# KAMI IRON ORE PROJECT

**Kami Iron Ore Project  
Amendment to the  
Environmental Impact Statement**

**VOLUME 3  
INFORMATION REQUEST RESPONSES**

February 2013

**Figure 1.1.2 Simplified Process Flow Diagram (PFD)**

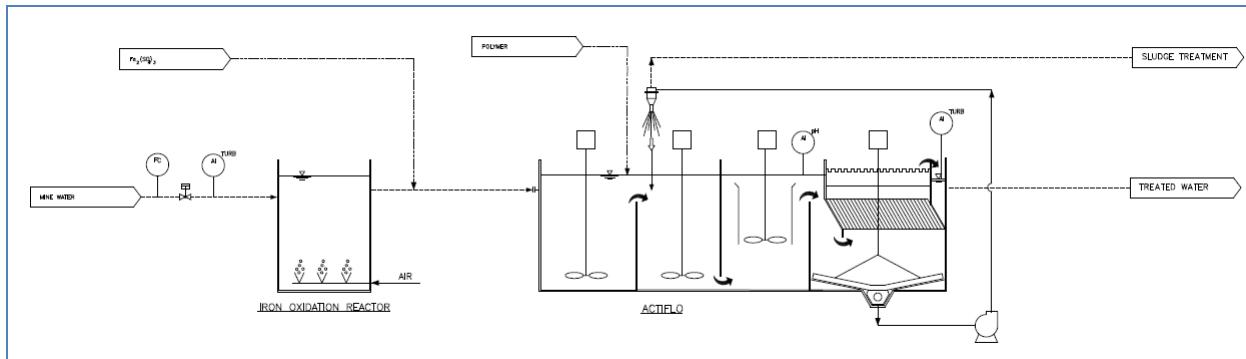
As iron may be toxic to fish, the statement relating to the toxicity of the red effluent should be reviewed and potentially revised.

As described in detail below, Alderon intends to apply mechanical treatment to effluent from the Tailings Management Facility to eliminate the potential for 'red water' issues and therefore any impact to fish.

The water from the TMF will be treated using Ballasted flocculation or "Mechanical Treatment", which is a high-rate coagulation-flocculation-sedimentation process applied in the water treatment industry. A simplified Process Flow Diagram (PFD) for the mechanical treatment is shown in Figure 1.1.2 below. The process includes the combined use of a micro sand and a polymer coagulant to get the iron particles to connect together to form a 'floc' which is heavier in weight and settles out of the water at an increased rate. The micro sand provides a surface area that enhances flocculation and acts as a "ballast" or "weight". The resulting floc settles quickly, allowing for higher flow rates, short retention times and the ability to provide treatment under dramatically changing flow rates without impacting final effluent quality.

The ballasted-flocculation process consists of two steps, oxidation and clarification. Water oxidation is conducted in an Oxidation Reactor where air is added to oxidize dissolved ferrous iron ( $Fe_2^{+}$ ) present in the water to form suspended ferric iron ( $Fe_3^{+}$ ) hydroxide particles. The water flows from the oxidation stage to a coagulation chamber where a coagulant is added to start the micro-flocculation and then to a Maturation tank where polymeric flocculant and microsand are added to continue floc formation. In this tank, a turbo-mixer creates ideal conditions for the suspended iron particles to combine with the microsand. From the Maturation tank, the fully formed iron sediments enter a settling tank equipped with a lamella clarifier, which provides the rapid and effective removal of the microsand/sludge floc. The clarified water exits the system via a series of collection troughs or weirs. The clarified water is monitored for turbidity to provide real-time monitoring of red water conditions and allow adjustments to the process to be completed if the turbidity increases above target discharge set points.

**Figure 1.1.3 Emergency Spillway Flow Path**

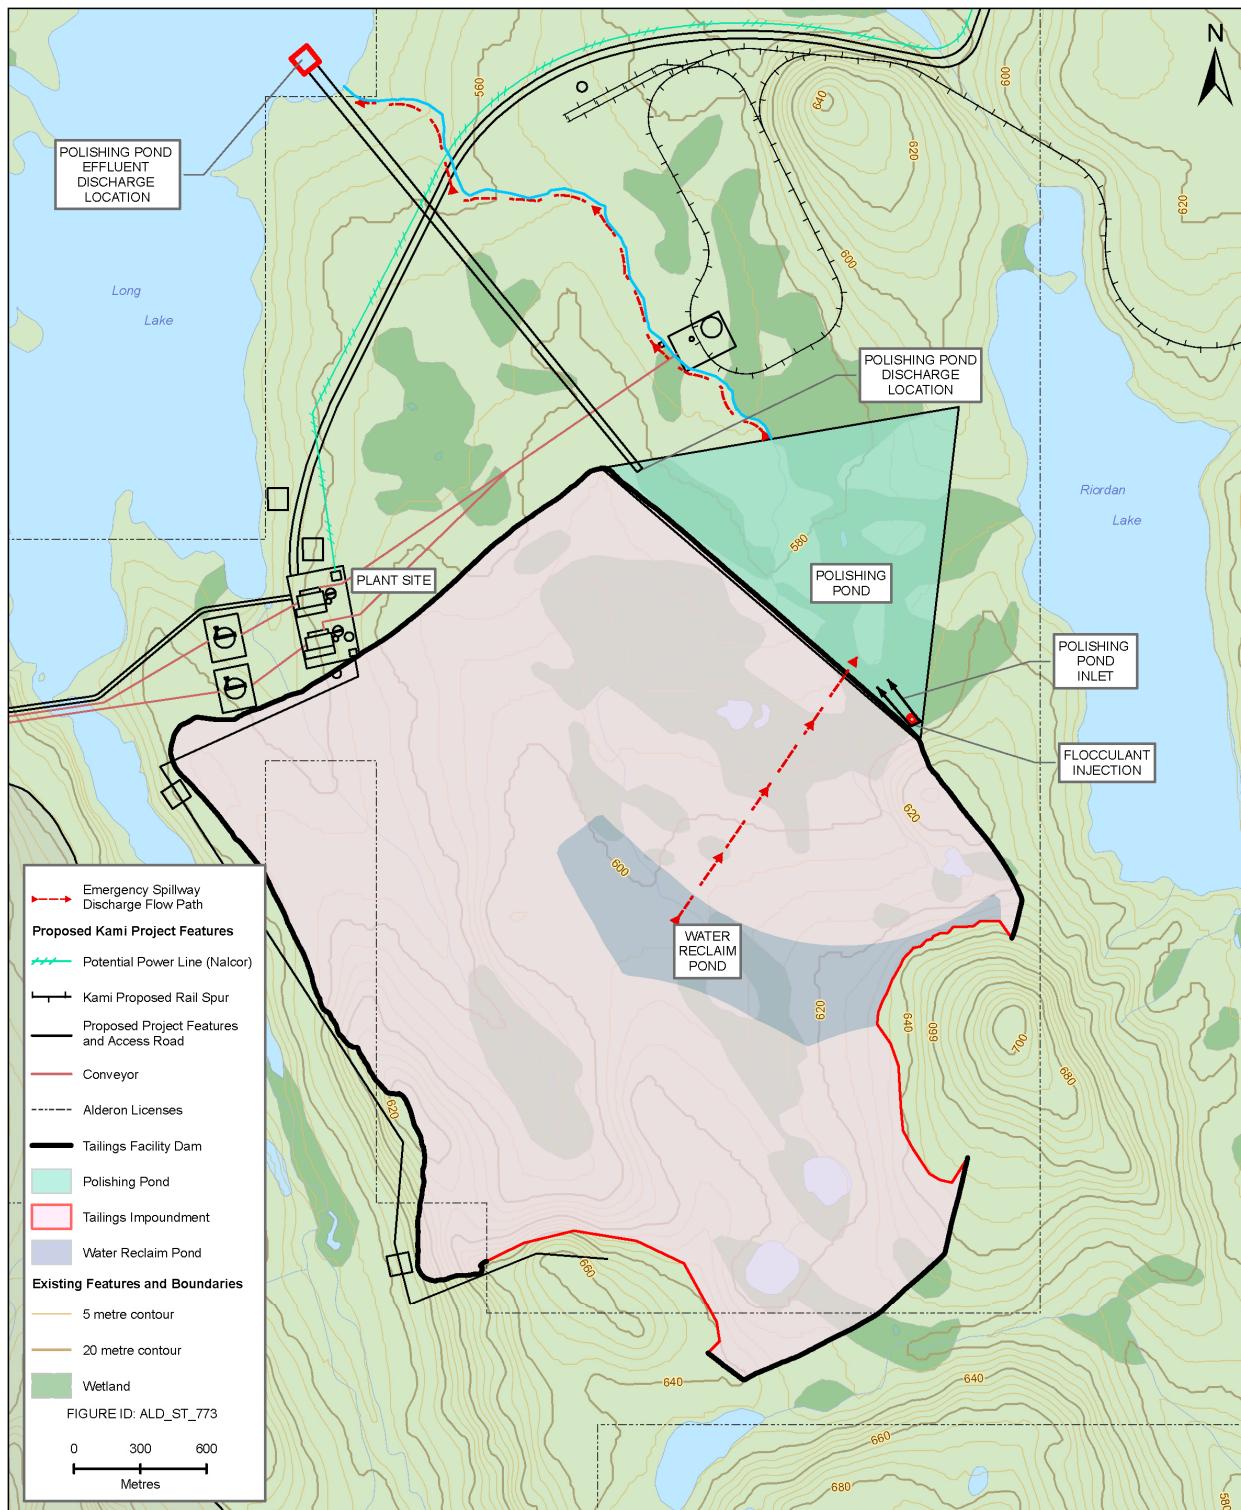
Proponent should provide detailed contingency and mitigation plan for each of the dyke break scenarios.

In the event of a tailings dam breach, tailings impoundment water would have to migrate through the tailings beach to the breach, and in the process, peak flows would be expected to be attenuated to low consequence levels. The emergency spillway will be located such that the flow path will be through the existing watercourse channel to Long Lake. The emergency spillway flow path to the tailings dam will be via the polishing pond and will reduce the suspended solids concentration leaving from the polishing pond. Water sampling would be carried out during an emergency discharge to measure the TSS concentration entering downstream waterbodies. Figure 1.1.3 shows the location of the emergency spillway flow path.

The Emergency spillway discharge flow path is shown in Figure 1.1.3 (Alderon Response to EC 19). The Emergency flow path from the tailings area to the polishing pond will be provided as shown in Figure 1.1.3. The emergency spillway will be located such that the flow path will be

Figure 1.1.4 Fuel Tank Farm Location and Preferential Spill Flow Path

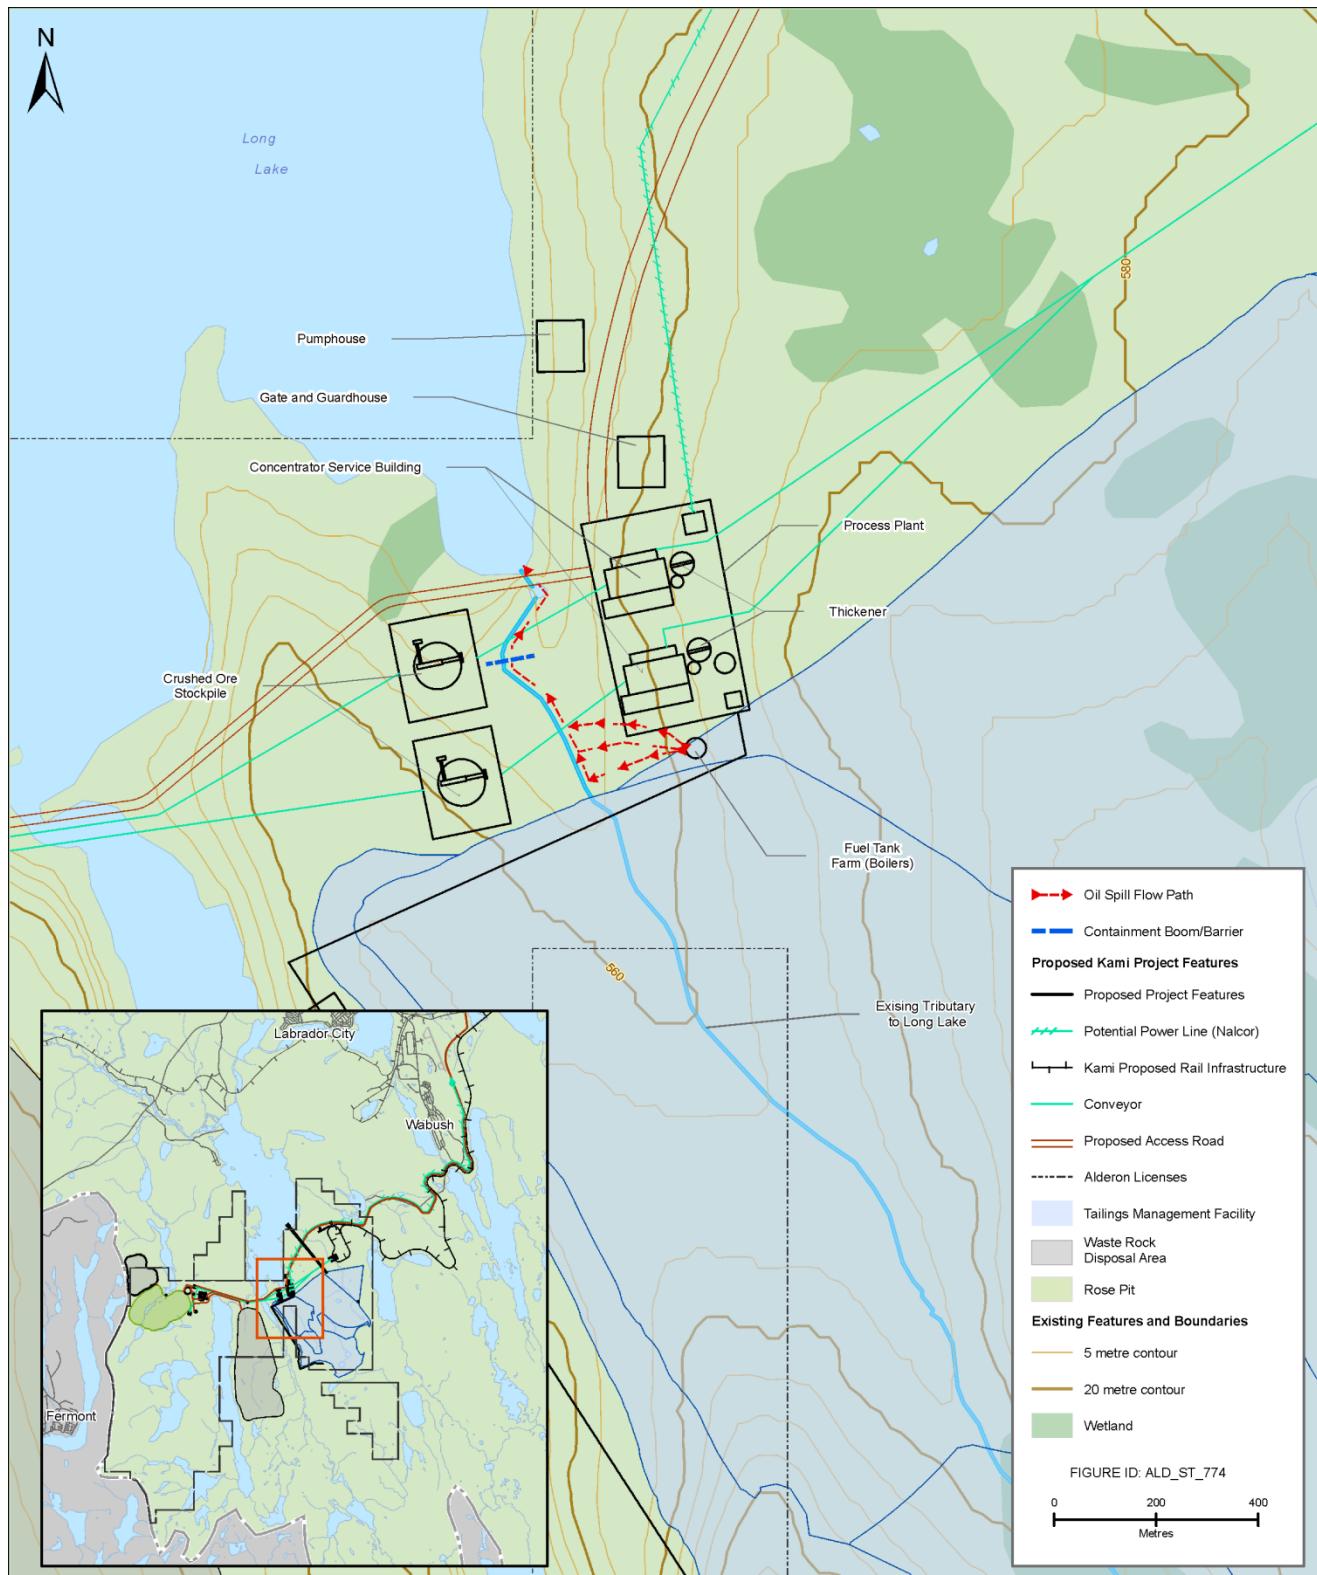
There is no information provided in regard to the unloading installation, secondary containment, procedures and emergency response and spill response plan. This information should be provided.

The Fuel tank farm is proposed to be located just downstream of the tailings dam and east of the small tributary of Long Lake as shown in Figure 1.1.4 below. The preferential oil spill flow paths are overland towards the small tributary and then into Long Lake via the small tributary (Figure 1.1.4) in the case of secondary containment breach.

Note that if during detailed design the tank farm is located within the mill battery limit, a secondary containment breach would drain toward a sedimentation pond which would form a tertiary containment system for an accidental release.

**Figure 1.2.2 Location of Specific Receptors**

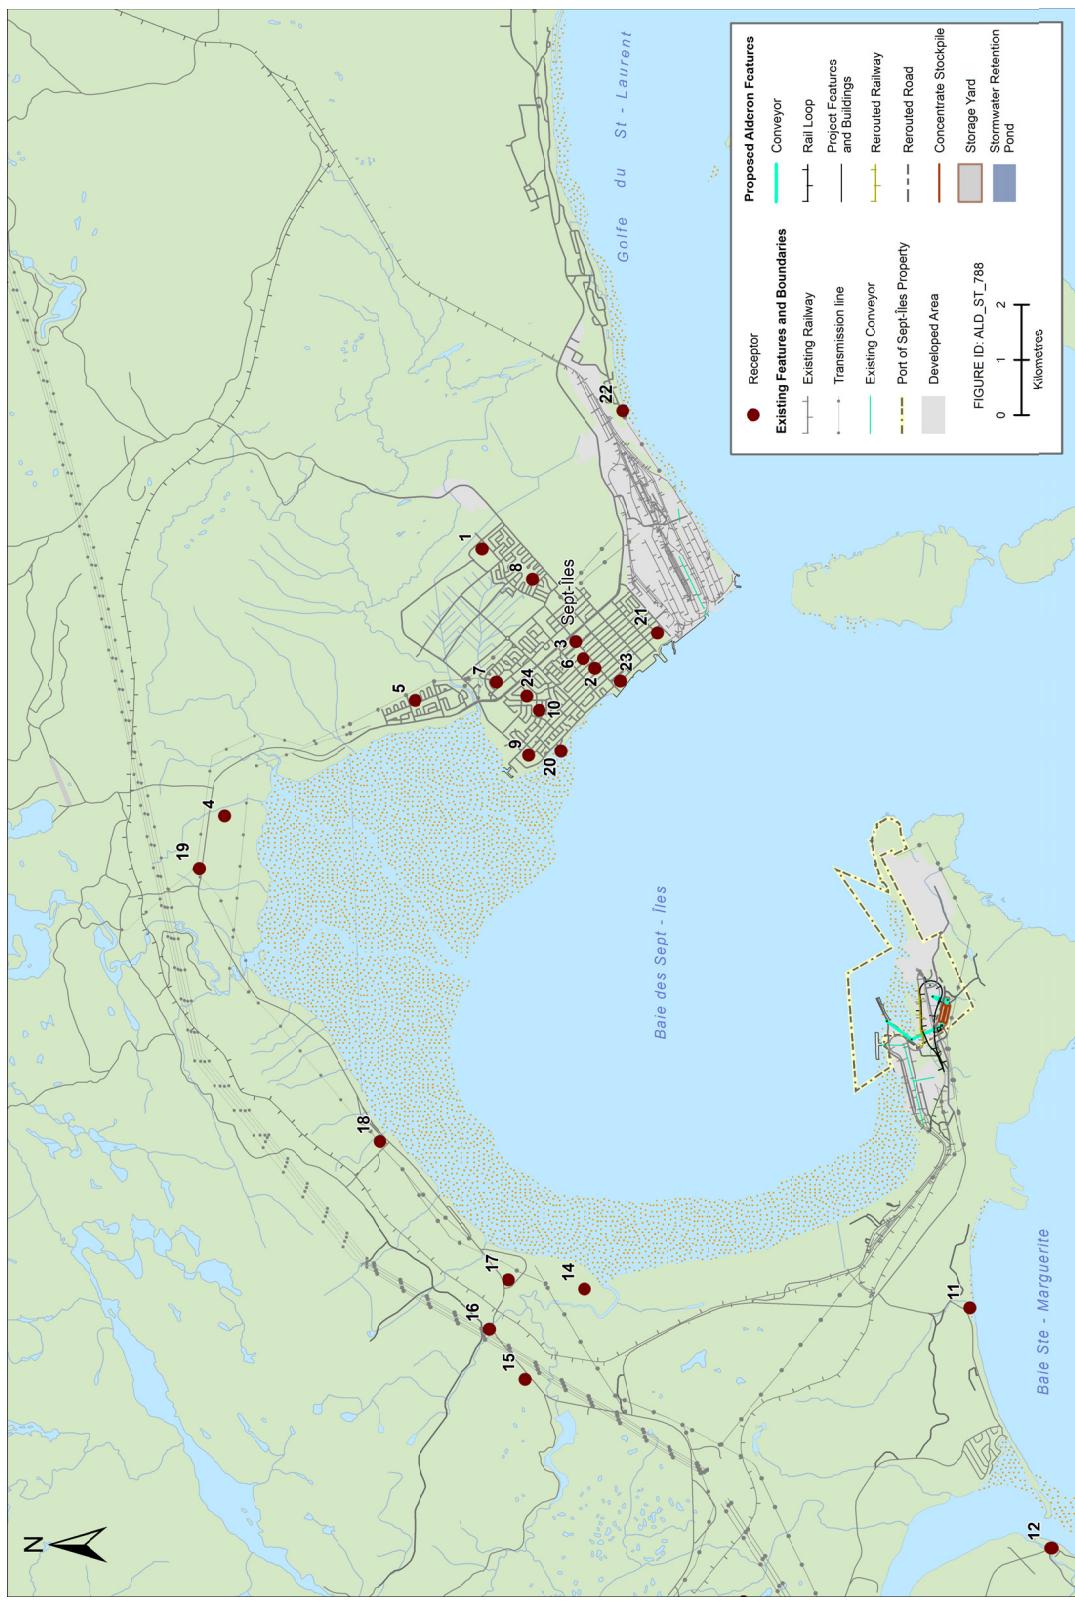
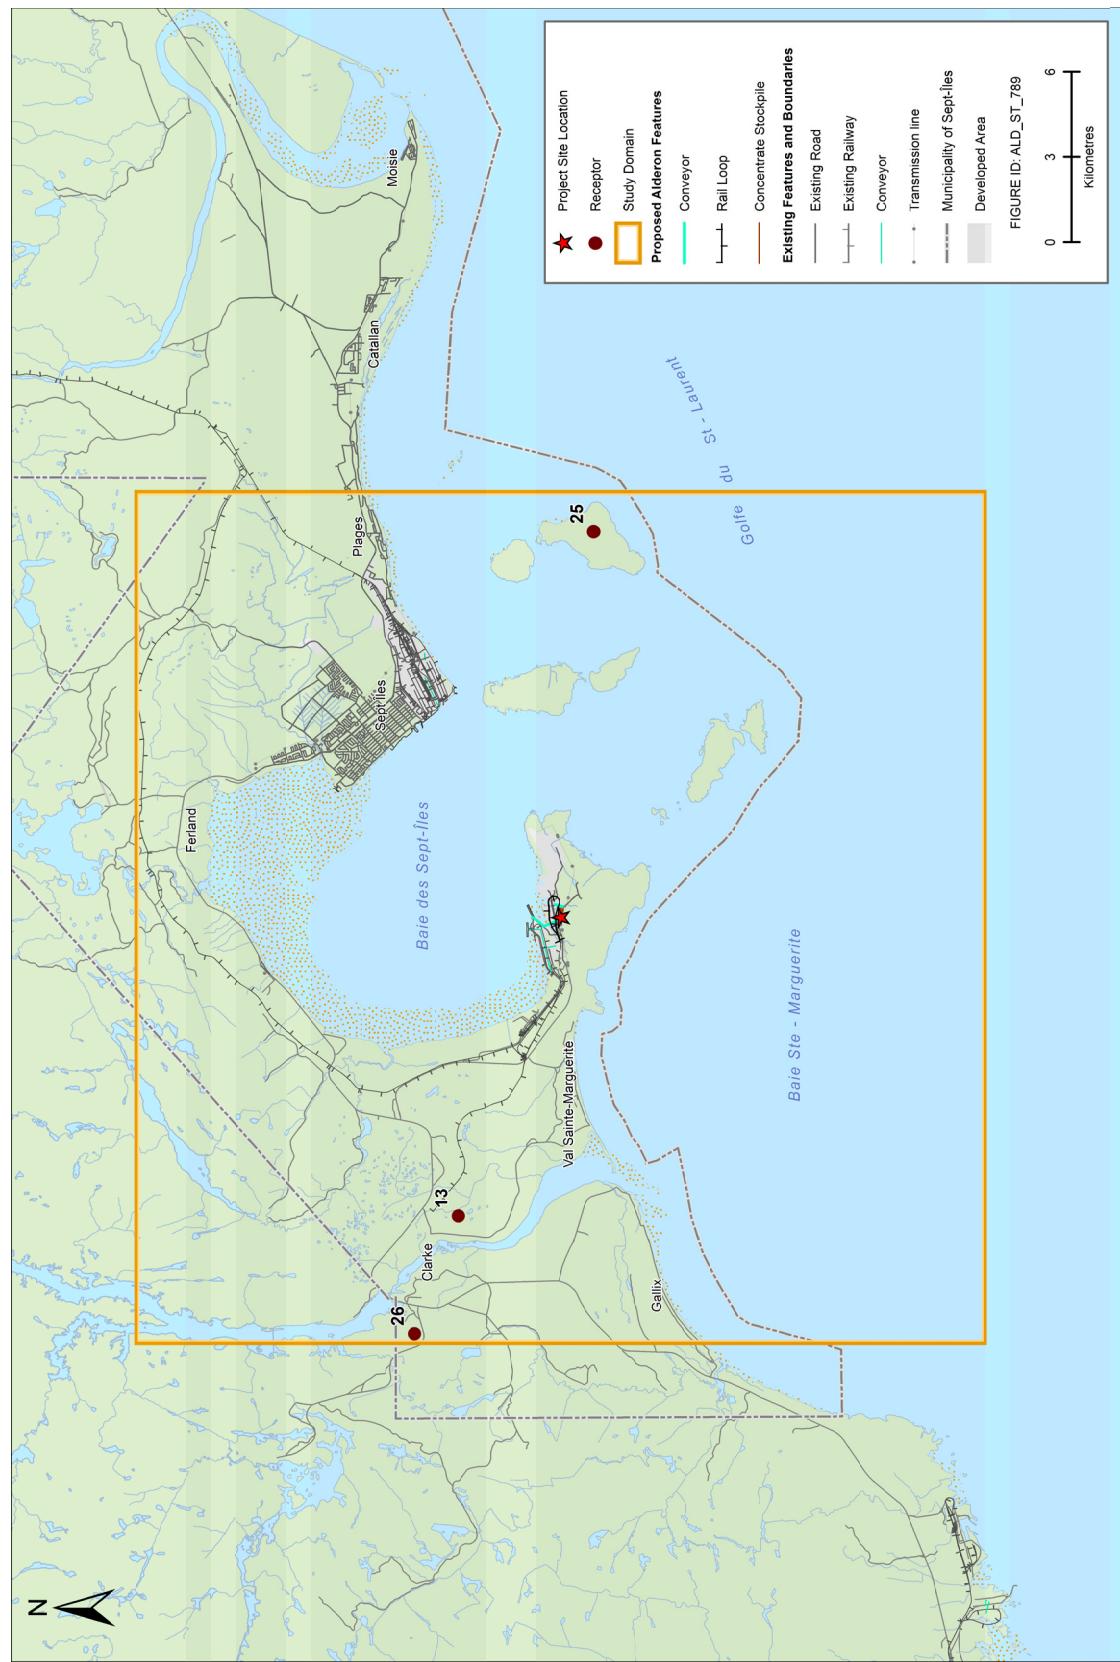
La Figure 4.11 de l'annexe G (page 46) montre 23 récepteurs sans aucune identification. Par ailleurs, les 26 récepteurs, mentionnés dans l'annexe F, sont décrits en termes de numéros avec leurs coordonnées UTM seulement. Quant au texte de l'annexe G, il indique 27 récepteurs.

Table 1.2.16 lists all the specific receptors, the type, name / description, and UTM coordinates. The two following figures (Figure 1.2.2 and Figure 1.2.3) show the location of each specific receptor. Some receptors were not visible in the original map presented in Figure 4.11 (Volume 2, Appendix G).

**Figure 1.2.5 Comparison of Wind Roses for Sept-Îles, for Two Different Time Periods**

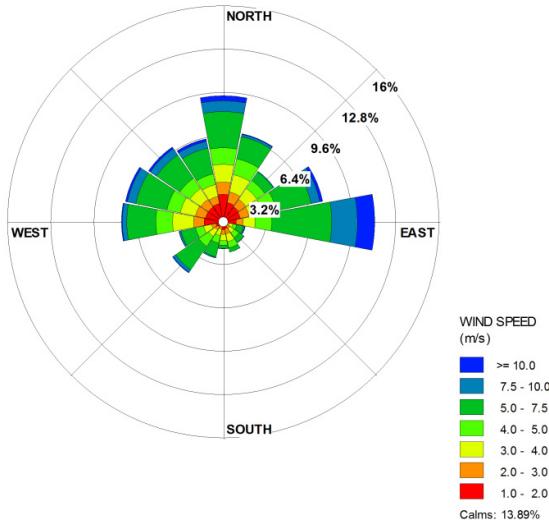
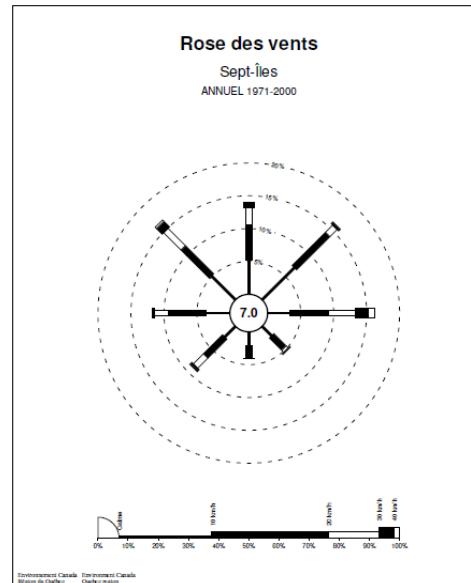
- Figure 2 (p. 7-6): wind rose, from 2005 to 2011→ the wind rose for Sept-Iles airport should cover a much longer period; the wind rose from 1971-2010 is available here: [http://www.climat-quebec.qc.ca/home.php?id=roses\\_vents&mpn=stats&lg=en](http://www.climat-quebec.qc.ca/home.php?id=roses_vents&mpn=stats&lg=en)

P. 14-24, last sentence should read: "The maximum gust speed was measured in January 1960, with a speed of 161 km/h."	The comment is acknowledged.
Figure 2 (p. 7-6): wind rose, from 2005 to 2011→ the wind rose for Sept-Îles airport should cover a much longer period; the wind rose from 1971-2010 is available here: <a href="http://www.climat-quebec.qc.ca/home.php?id=roses_vents&amp;mpn=stats&amp;lg=en">http://www.climat-quebec.qc.ca/home.php?id=roses_vents&amp;mpn=stats&amp;lg=en</a> . Same comments for pages 14-24; 14-25 (wind roses) as in Chapter 7.	Figure 1.2.5 shows the Sept-Îles Airport wind rose obtained from two different time periods. Both wind roses although they do not cover the same time period and do not have the same sub-divisions, show a generally similar pattern, with perhaps a more important portion winds from the north-east in the 1971-2000 wind rose. For Pointe Noire, this comparison was not possible, since wind measurements at that station are only available since 1997.
